Key Documents Related to the Recirculation of Portions of the Draft Environmental Impact Report

Horizon West Transmission, LLC's Original Comments on the Draft Environmental
Impact Report

Re: Comments of Horizon West Transmission, LLC on the Draft Environmental Impact Report for the Estrella Substation and Paso Robles Area Reinforcement Project, December 2020 (California State Clearinghouse No. 2018072071)

Figure 2. Preliminary Plan

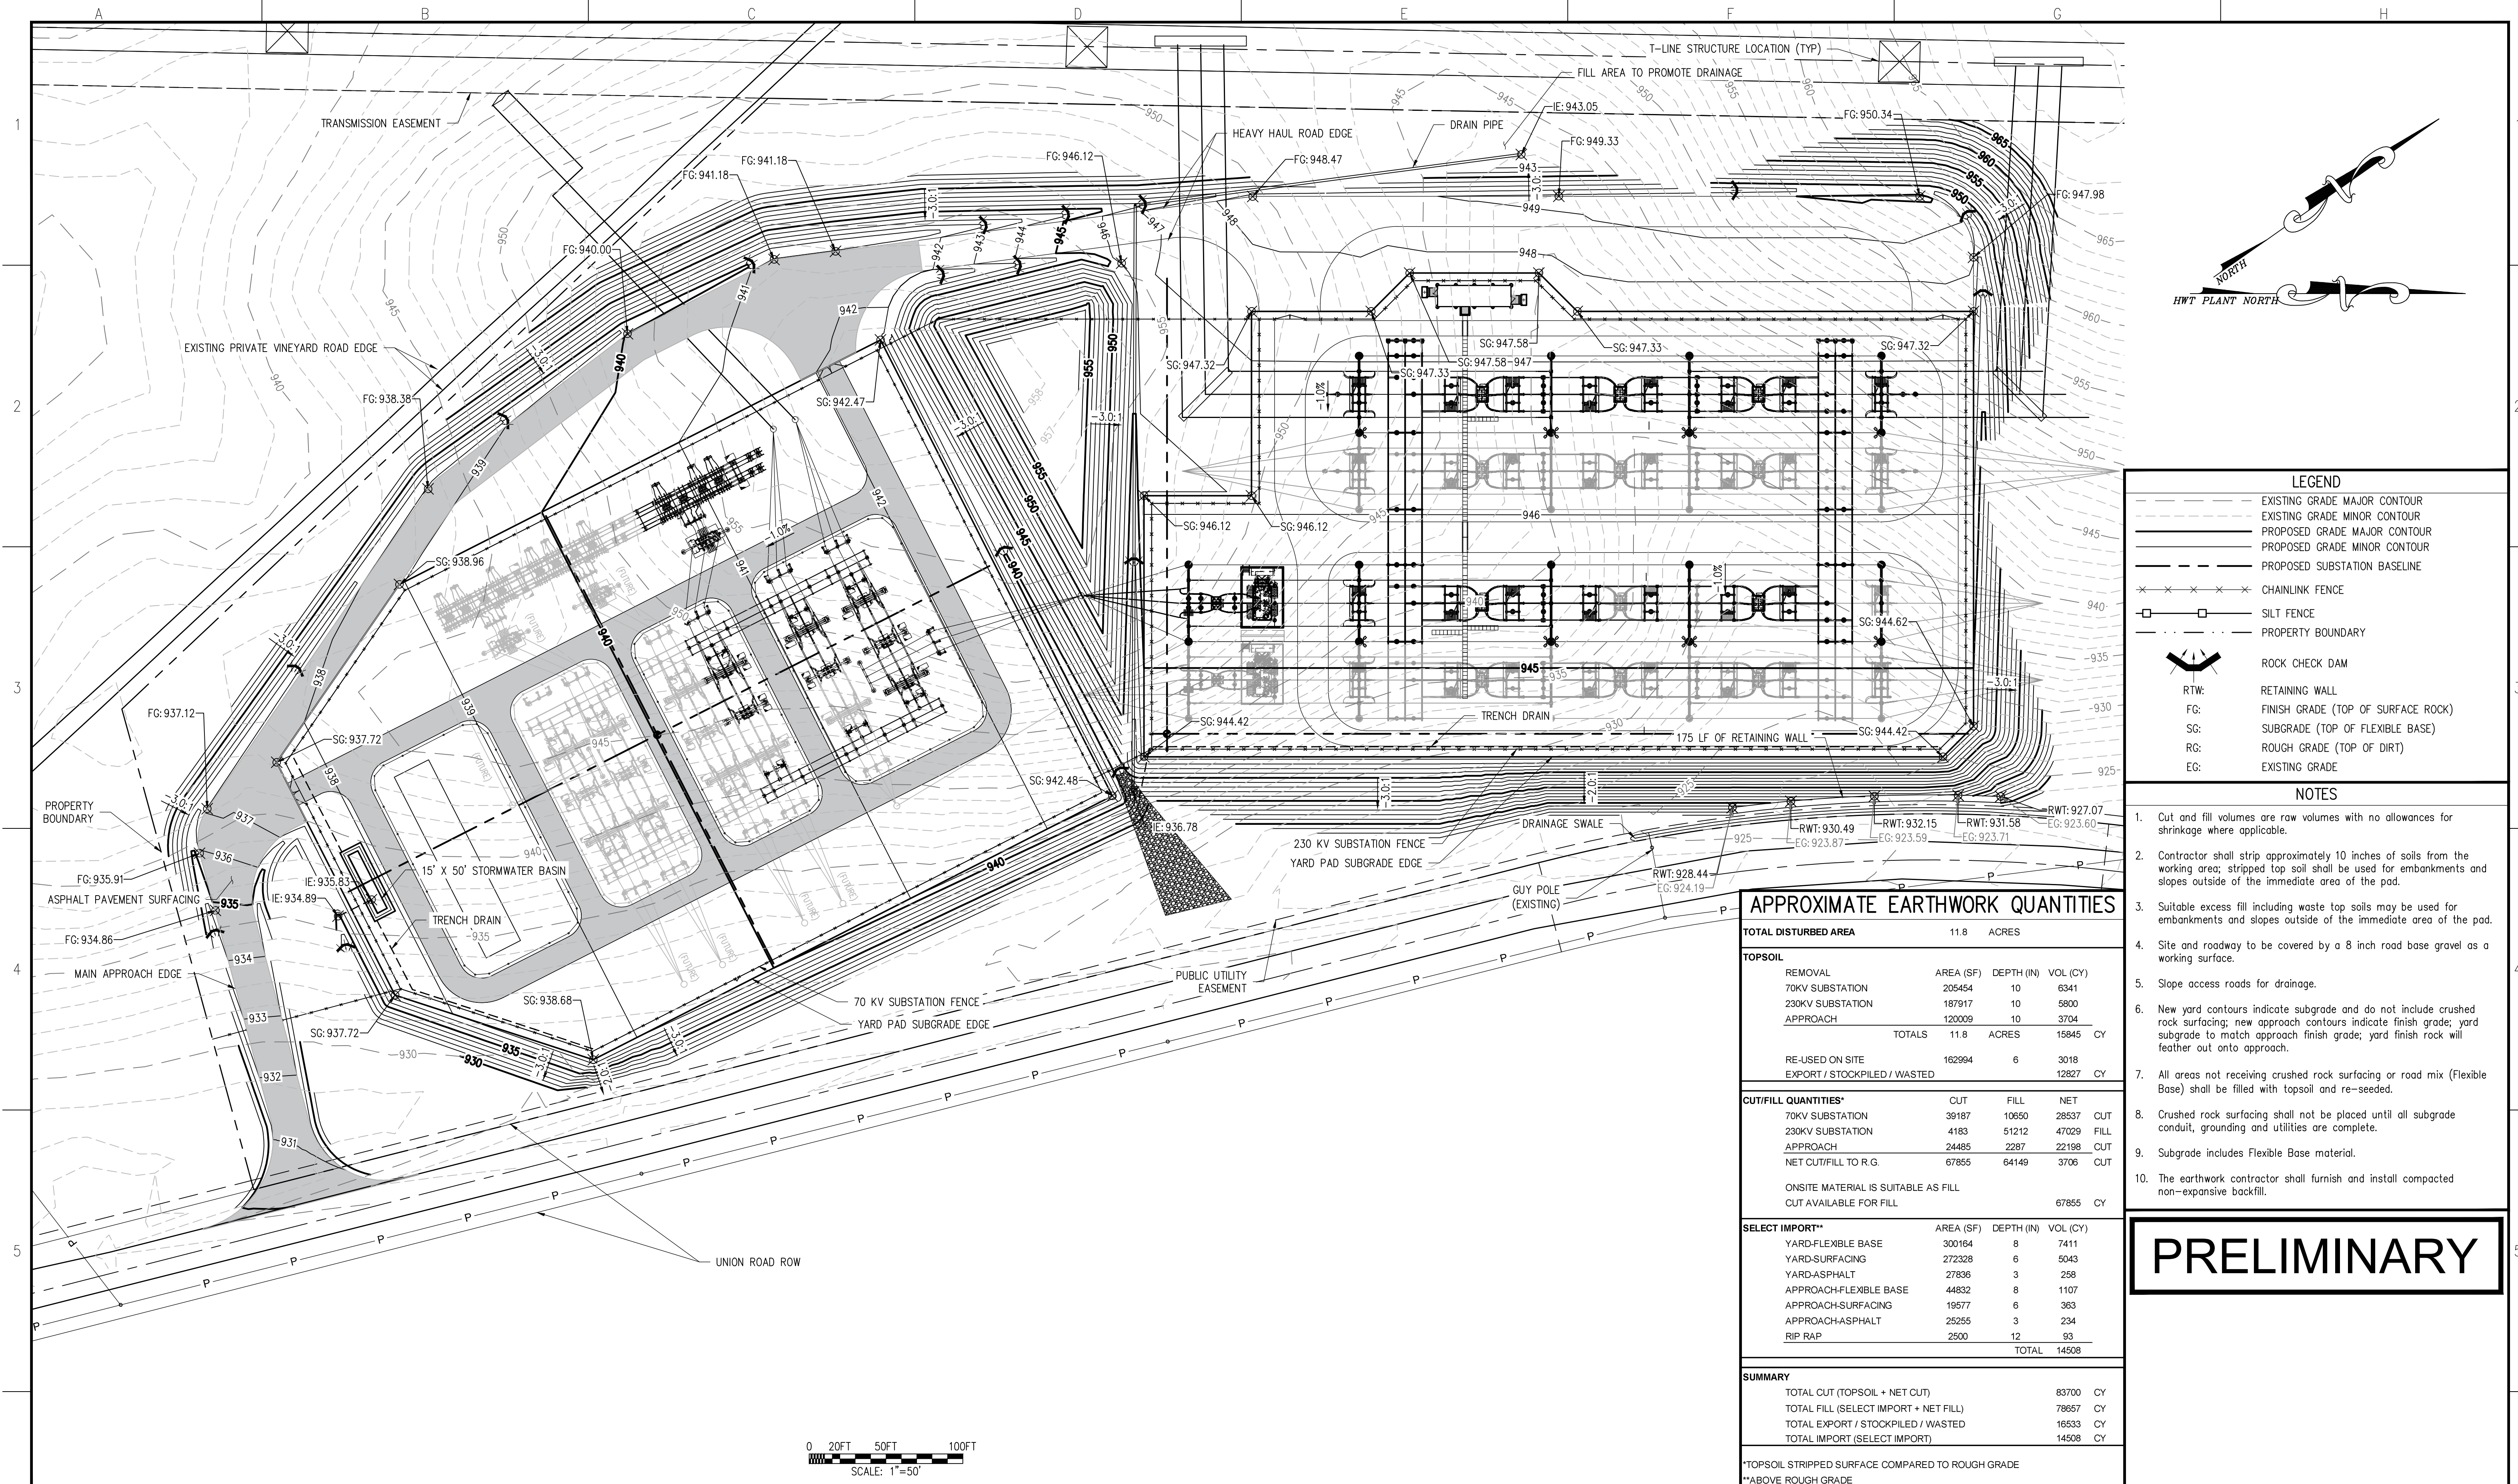
At its closest point, the fence line will be located approximately 64 feet northwest of Union Road, as shown in Figure 2 in **Attachment 1** hereto. Without this change, the design would preclude access to the five-acre addition to the site. This slight reorientation will require approximately 72,000 cubic yards of cut and fill, which will be balanced on site to the extent feasible. The MPR will only result in a slight reconfiguration of the yard equipment and will not affect the type of electrical equipment to be housed within the site's fence line as originally proposed.

Figure 2-1
Existing Transmission System

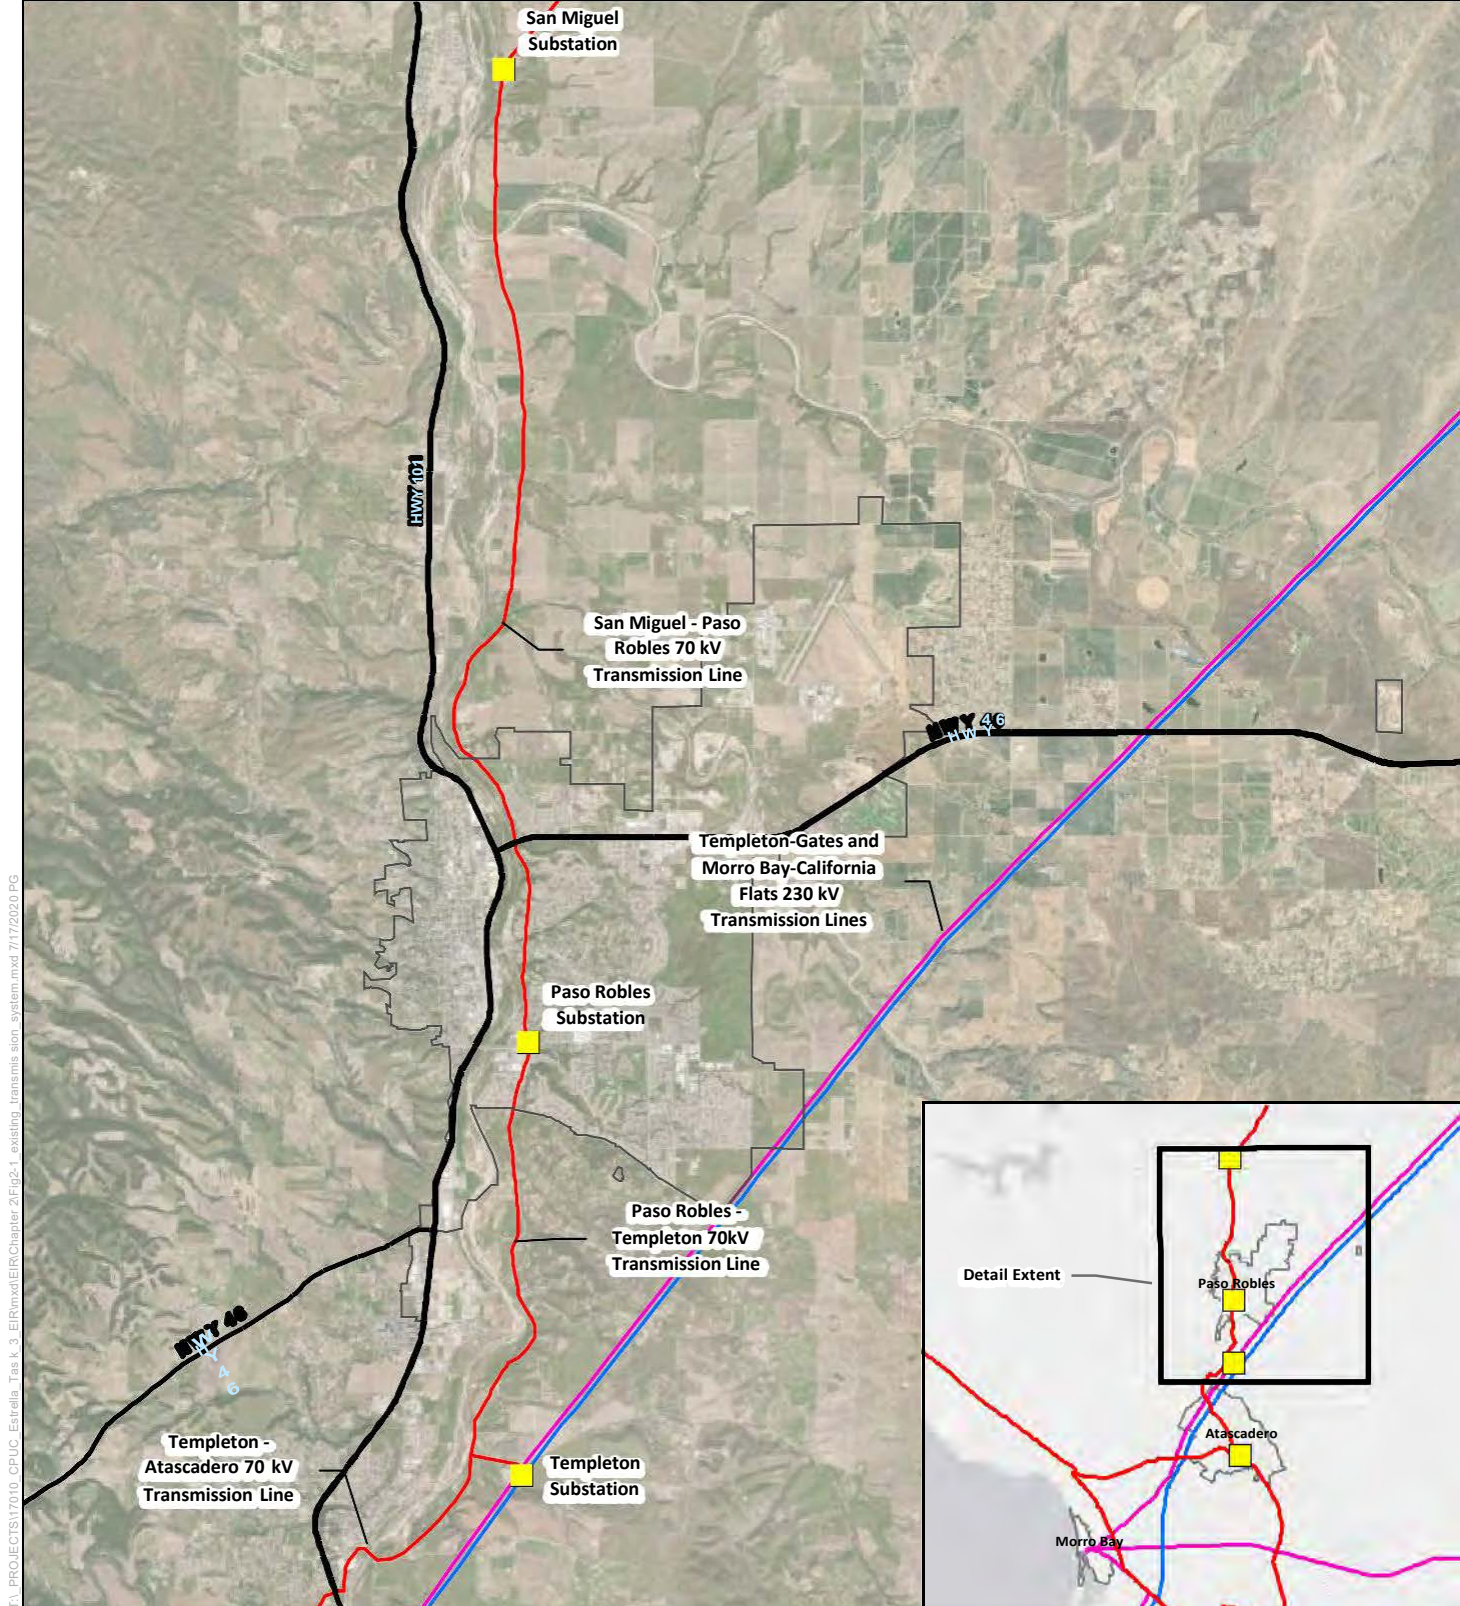
CHAPTER 2 - PROJECT DESCRIPTION		
2-4	Figure 2-1	The 500kV line is north of the 230 kV line, not south as currently depicted in the figure.
2-15	Topography in the vicinity of the Proposed Project is generally rolling hills, with existing elevations ranging from approximately 920 feet to 960 feet above mean sea level	<p>Please revise text to read:</p> <p>Topography in the vicinity of the Proposed Project is generally rolling hills, with existing elevations ranging from approximately 920 feet to 960 <u>970</u> feet above mean sea level</p>
2-15	Topography in the vicinity of the Proposed Project is generally rolling hills, with existing elevations ranging from approximately 920 feet to 960 feet above mean sea level.	<p>The maximum elevation of substation parcel is approximately 970 feet.</p> <p>Revise text to read:</p> <p>Topography in the vicinity of the Proposed Project is generally rolling hills, with existing elevations ranging from approximately 920 feet to 960 <u>970</u> feet above mean sea level.</p>

Estrella Substation and
70 kV Power Line Components -
Detailed View
Sheet 1 of 8

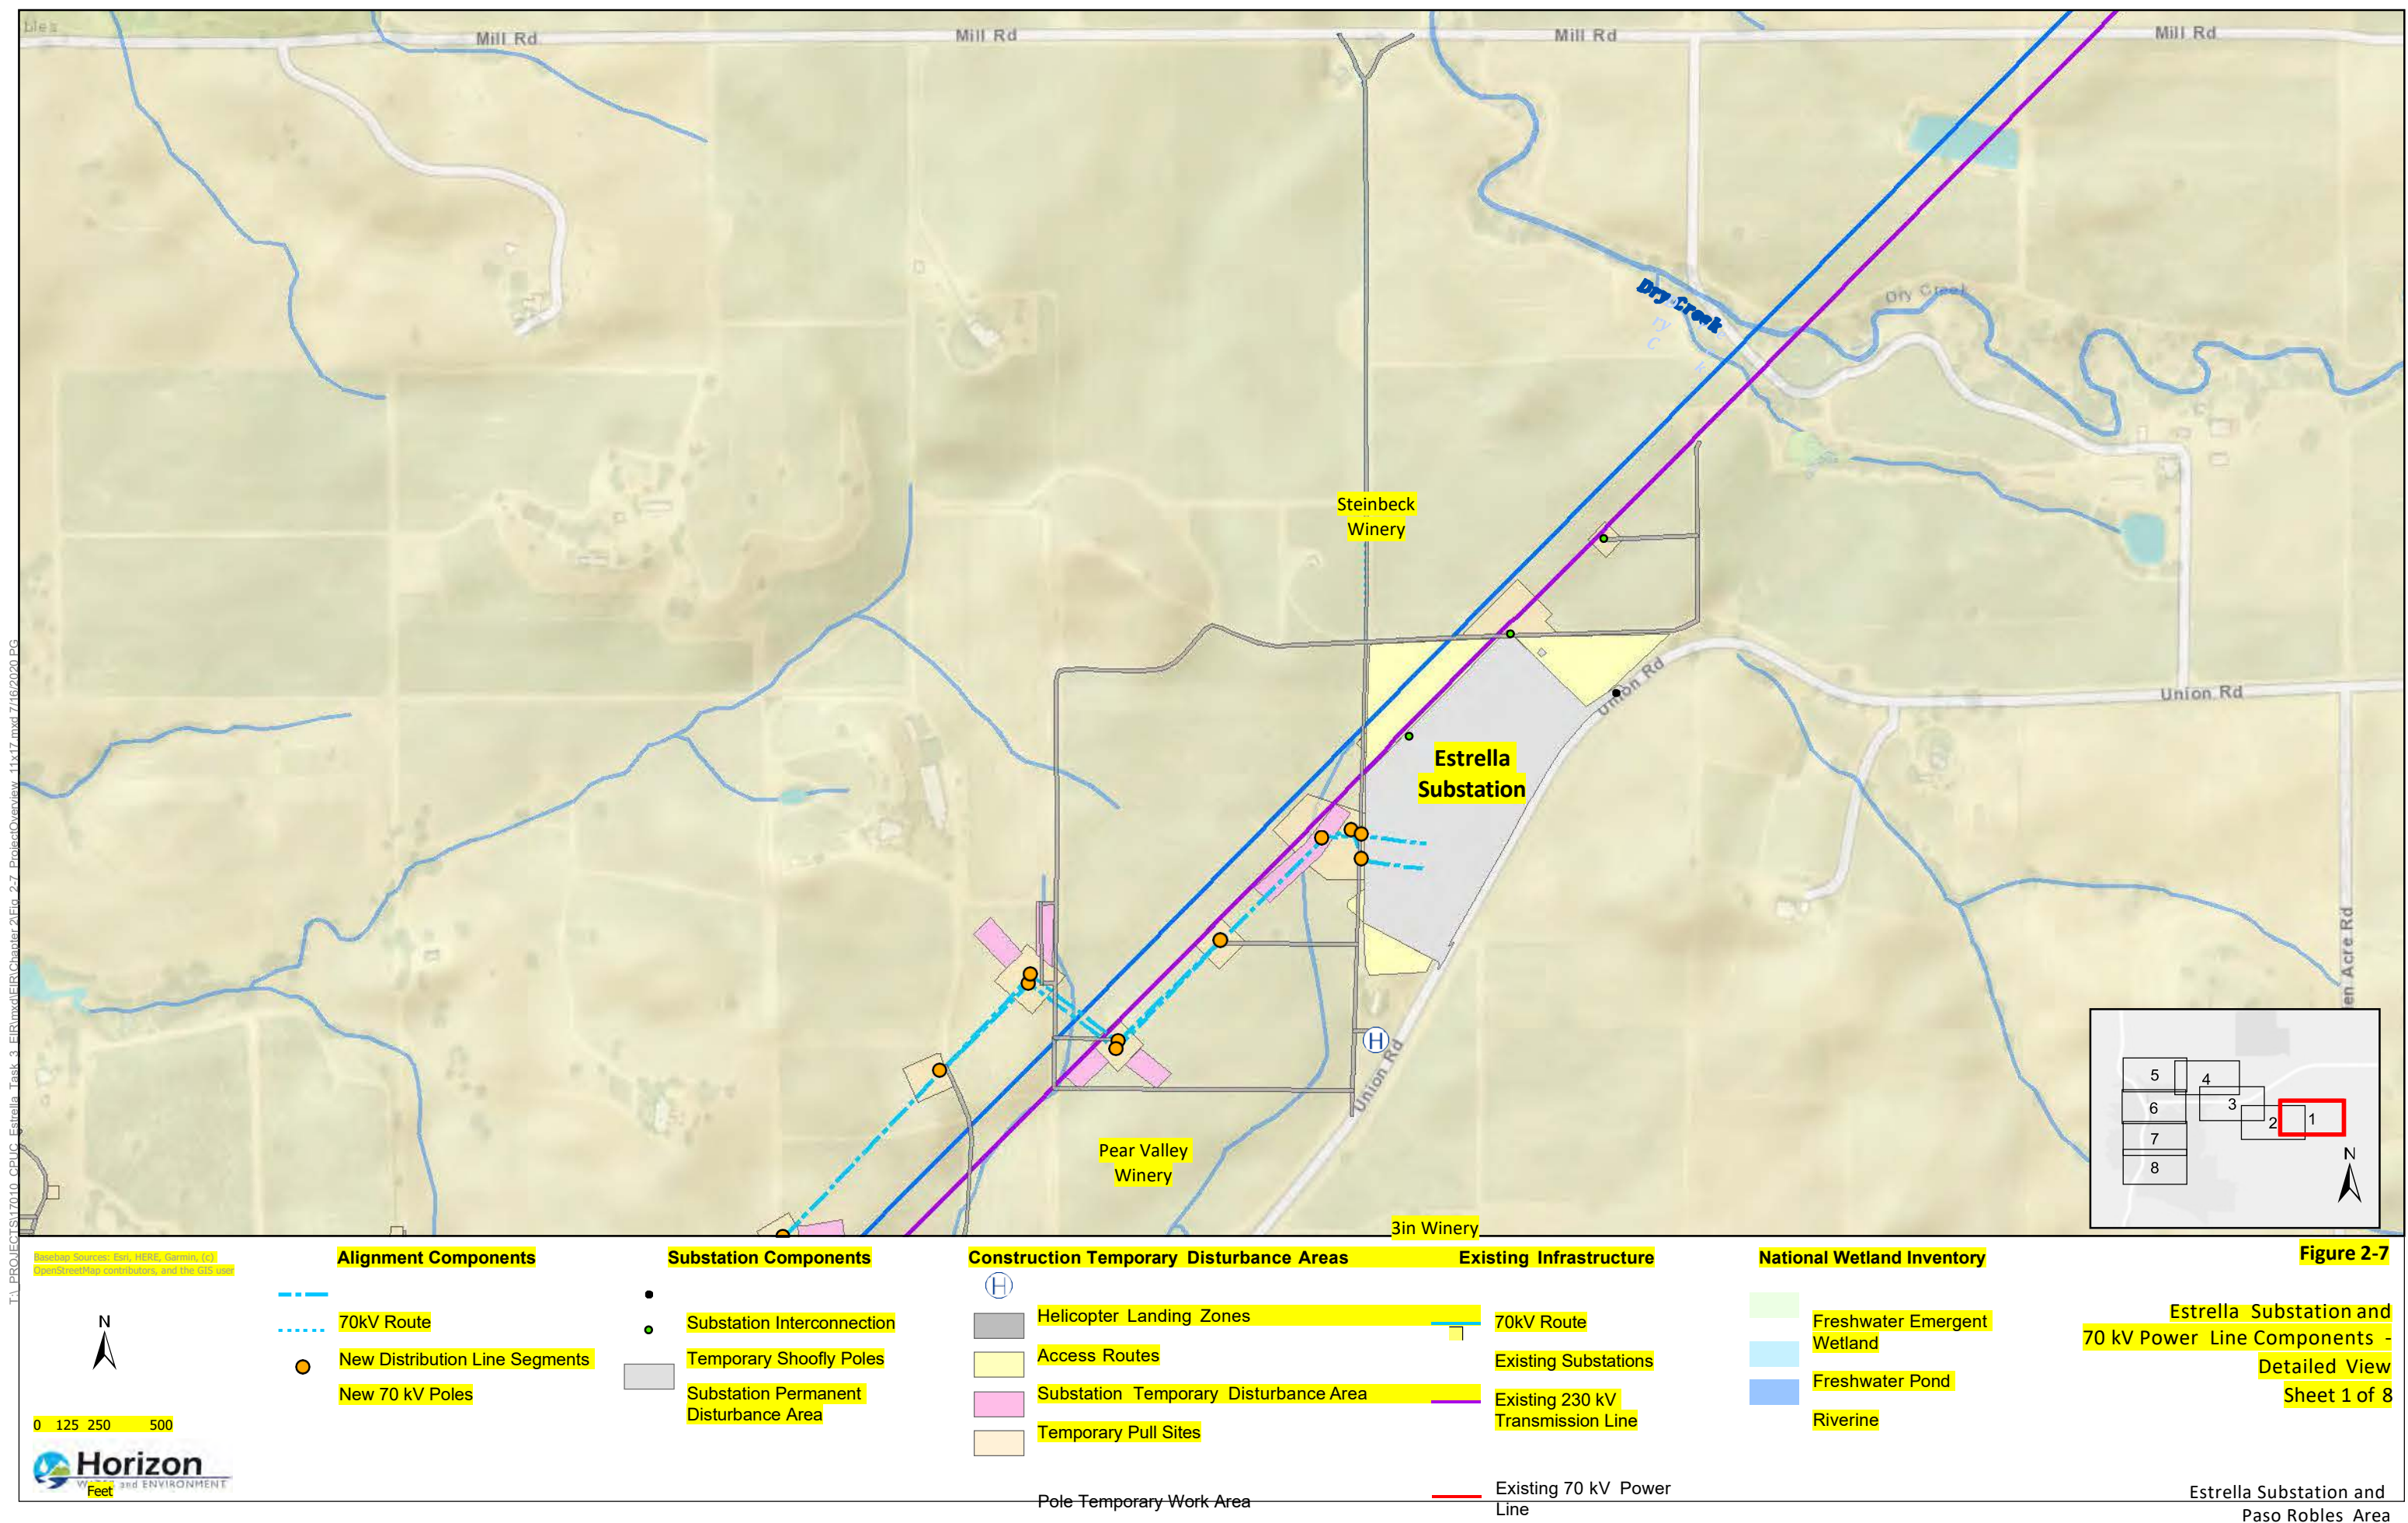
2-22	Figure 2-7	Replace figure to include new substation parcel and update temporary and permanent disturbance areas
2-46	Figure 2-11	Replace figure with new substation layout
2-47	Figure 2-12	Replace figure with new substation layout
2-48	Figure 2-13	Replace figure with new substation layout
2-49	The fenced portion of the 230 kV substation would be approximately 4 acres in size. An approximately 7-foot-tall chain-link fence with an additional 1 foot of barbed wire would be installed around the remaining perimeter of the 230 kV substation.	Please revise text to read: The fenced portion of the 230 kV substation would be approximately 4 acres in size. An approximately 7-foot-tall chain-link fence, <u>a minimum of 7 feet tall</u> , with an additional 1 foot of barbed wire would be installed around the remaining perimeter of the 230 kV substation.
2-56	The equipment and facilities associated with ultimate substation buildout would primarily be placed within the fence line of the already-constructed Estrella Substation. The anticipated layout of the Estrella Substation at ultimate buildout is shown in Figure 2-18. The additional 230/70 kV transformer under ultimate buildout is assumed to include the same amount of mineral oil (16,000 to 18,000 gallons) as described for the Proposed Project (see Section 2.3.1), and the same secondary containment structure (i.e., designed to allow sufficient freeboard to include the oil volume of the transformer plus the precipitation from a 25-year, 24-hour storm event). The additional 230 kV interconnection is assumed to include similar structures (LSTs) and follow a similar interconnection process to that described for the Proposed Project in Section 2.3.1 under the header for “230 kV Transmission Interconnection.” The additional 70/21 kV transformers that may be installed to support additional distribution feeders are assumed to include secondary containment, as necessary to contain spills of any stored mineral oil.	Please revise text to read: The equipment and facilities associated with ultimate substation buildout would primarily be placed within the fence line of the already-constructed Estrella Substation. The anticipated layout of the Estrella Substation at ultimate buildout is shown in Figure 2-18. The additional 230/70 kV transformer under ultimate buildout is assumed to include the same amount of mineral oil (16,000 to 18,000 gallons) as described for the Proposed Project (see Section 2.3.1), and the same secondary containment structure (i.e., designed to allow sufficient freeboard to include the oil volume of the transformer plus the precipitation from a 25-year, 24-hour storm event). The additional 230 kV interconnection is assumed to include similar structures (LSTs) and follow a similar interconnection process to that described for the Proposed Project in Section 2.3.1 under the header for “230 kV Transmission Interconnection.” The additional 70/21 kV transformers that may be installed to support additional distribution feeders are assumed to include secondary containment, as necessary to contain spills of any stored mineral oil.

6	Project Description (MPR Technical Memorandum)	Please provide a revised Figure 2-7 (and GIS data for the figure) of the DEIR. This figure should clearly depict updated areas of permanent and temporary impacts as described in the MPR. Please ensure the extended access road is clearly depicted.	4/30/21	5/21/21			Revised Figure 2-7 (Sheet 1 of 8) is provided in Attachment C. The corresponding GIS data has been provided in the email transmittal of HWT's response to Data Request #6.
